NUMBER OF CONNECTIONS

60776

Nissens radiator 60776 covers both first and second version of BMW radiators which have different number of connections.

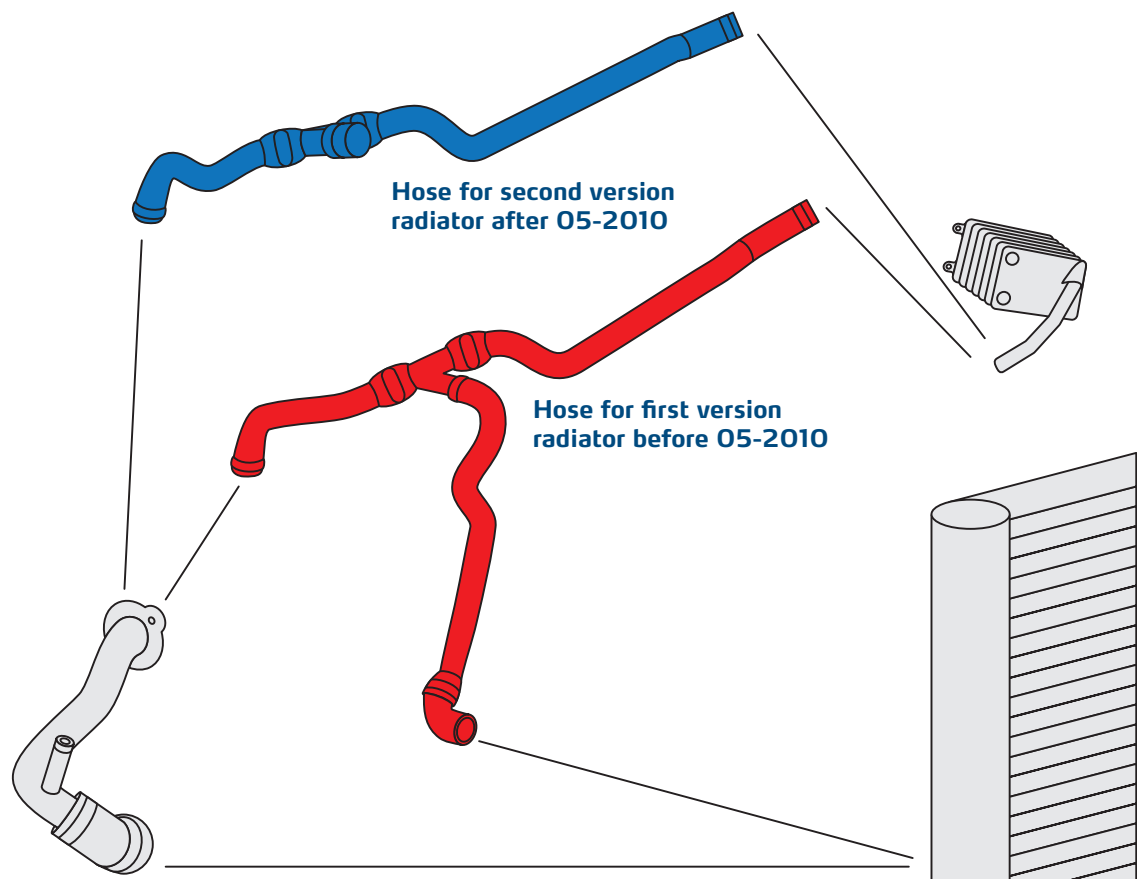
The first BMW radiator version had 4 connections used in connection with hose OE 1153 7581 870 (red). This expired 05-2010.

In the first version the hose is also connected to the fourth connection in the radiator.

The second BMW radiator version after 05-2010 only has 3 connections used with hose OE 1153 7581 872 (blue).

In the second version the hose is only connected to three connections in the radiator.
